Minutes – East Kildonan-Transcona Community Committee – September 3, 2026

Item No. 2 Rezoning – 513 Pandora Avenue West
(Transcona Ward)
File DAZ 211/2026 [c/r DCU 133692/2026D and DAV 133682/2026D]

Title: DAZ 211/2026 – 513 Pandora Avenue West

WEST ELEVATION
SCALE 1/8" = 1'-0"

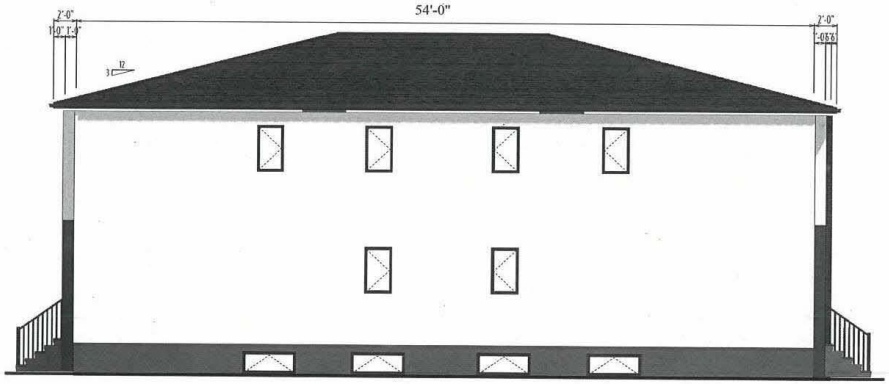
K. That all windows on the west side of the building be glazed."

G. GIBBS
DESCRIPTION
SITE & LANDSCAPING
1

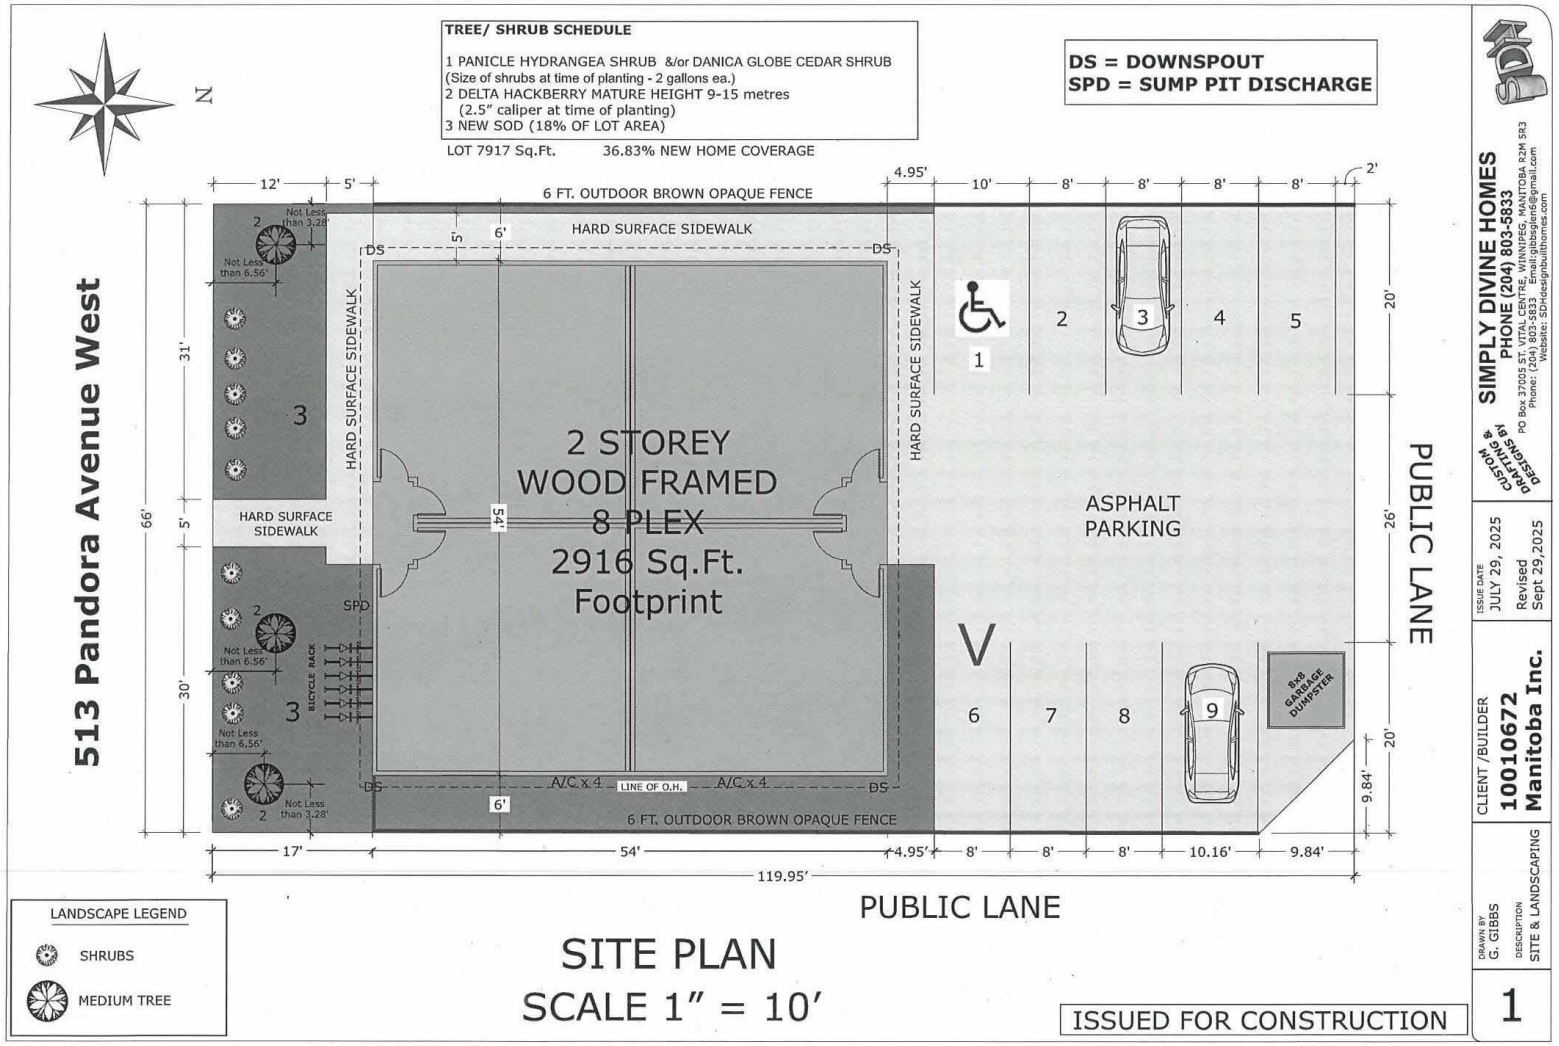
"E. That the hard surface sidewalk indicated on the site plan between the north and south entrances along the west side of the building be relocated to the east side of the building.

F. That the parking configuration be changed to accommodate a minimum of a four-foot, landscaped buffer along the west property line.

G. That the entrance of the parking lot be reduced from 7.9 metres (26 feet) to 6.7 metres (22 feet).

H. That a two-foot landscaped buffer be placed north of the reconfigured sidewalk that wraps around the building on the east side.

I. That a 4.95-foot landscaped buffer be placed at the rear of the building on both sides of the rear entrance

1. I'm happy to hear that the applicant is supportive of upgrading landscaping, upgrading the parking lot to ensure there is proper buffering for residents so they're not looking into a parking lot or have lights shining in, that there will be a proper fence, solid fence, so that lights will not be shining in, that there will now be a four-foot buffer minimum, possibly more he indicated.

2. I'm of the opinion that sometimes the 20-foot-wide access drive in to the stalls is too big, so bring it down today to 22 feet. It's more appropriate for vehicles sometimes these days.
